# improvement PA Bias power up time

28 Sep. 2021 J11UDD

## Cause: Slow PA Bias power up

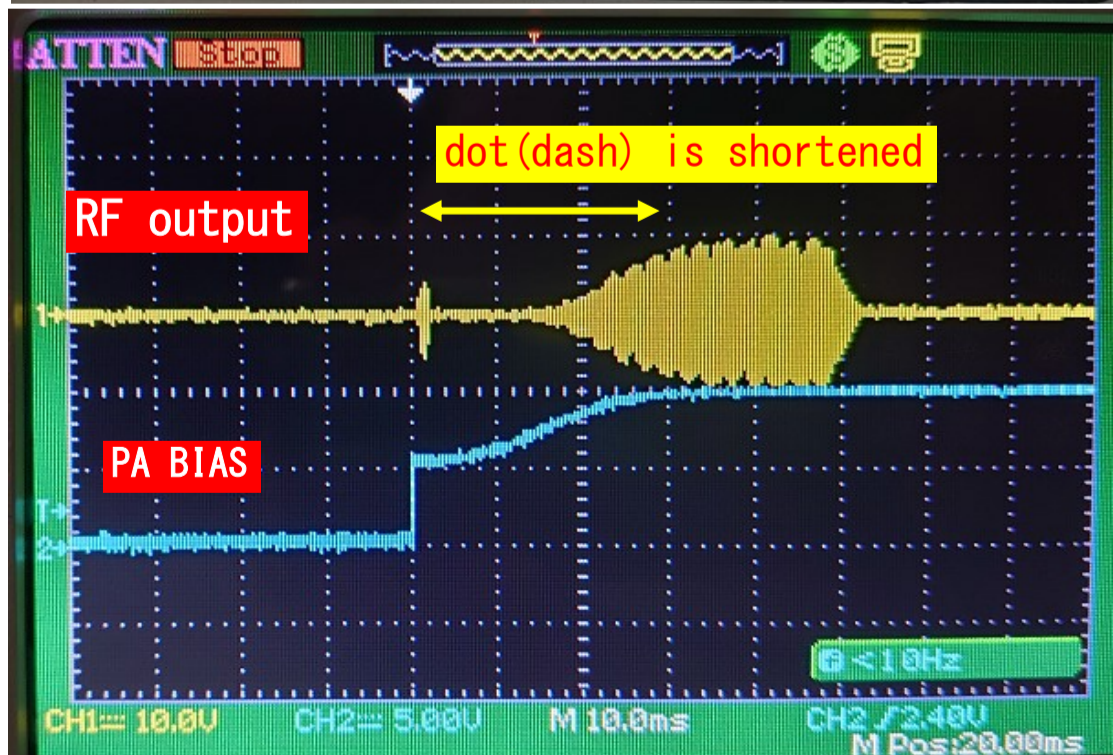
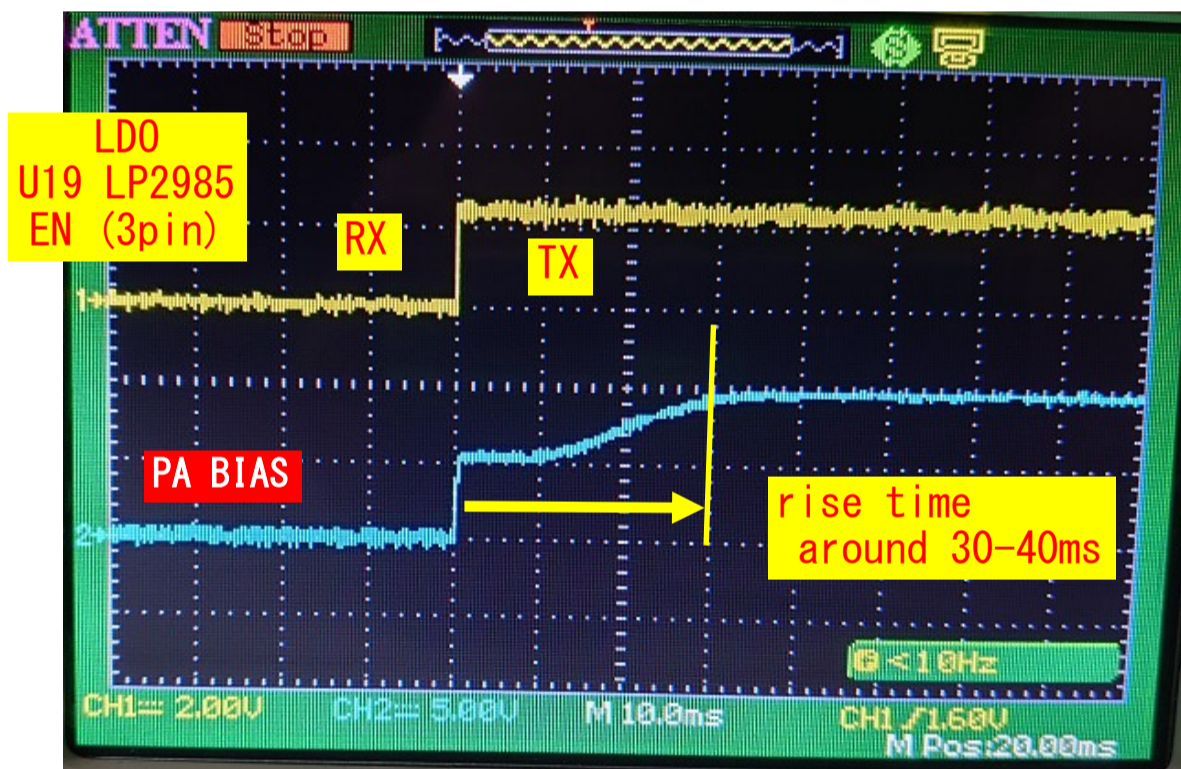
I found **slow PA Bias power up**. The power up time is wanted to be as short as possible to minimize Key Down delay.

Note : The rise time of PA Bias depends on the individual characteristics of U19 and B109.

## PA Bias circuit improvement

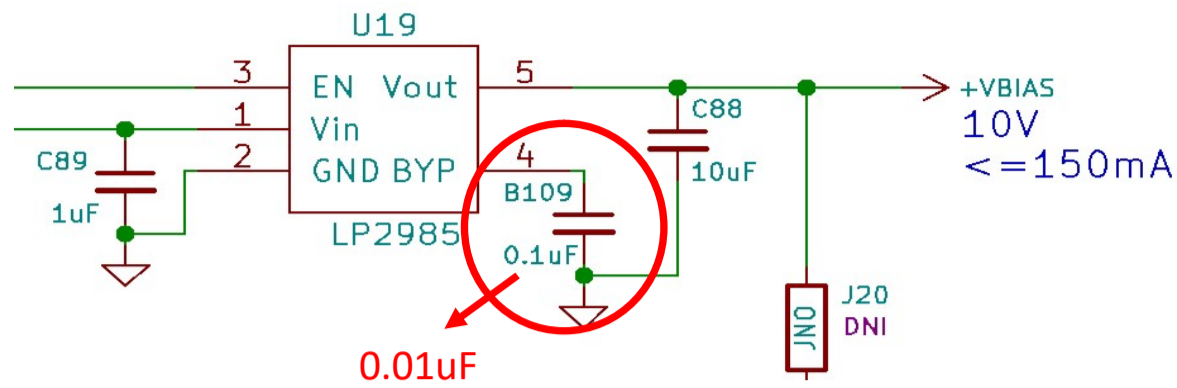
Replace 0.1uF with 0.01uF at B109.

According to TI LP2985 datasheet, 0.01uF(=10nF) is recommended for the BYPASS capacitor.  
In my test, TDK C1608C0G2A103J080AC is used as the new component.

## After replacement

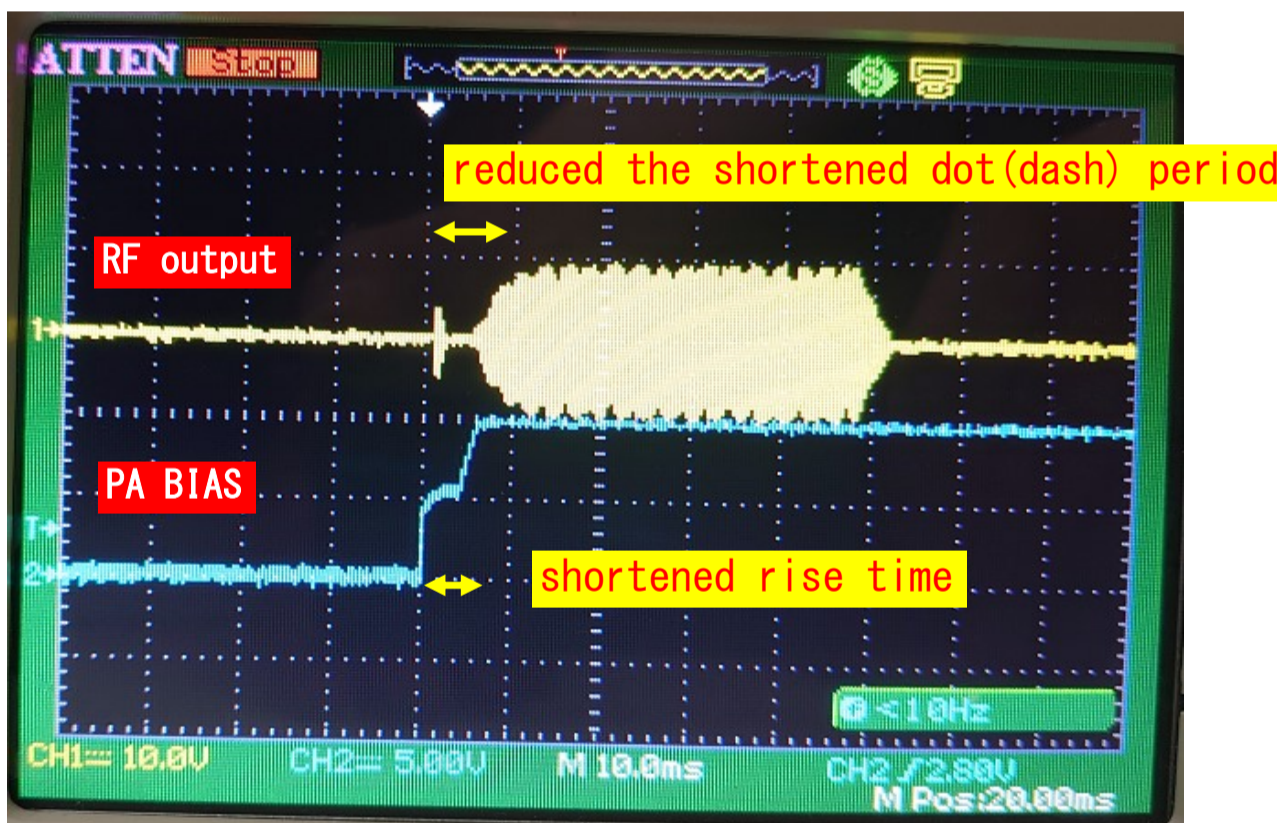
After replacement, if Key Down Delay is set to 10ms or more, the waveform is perfect !
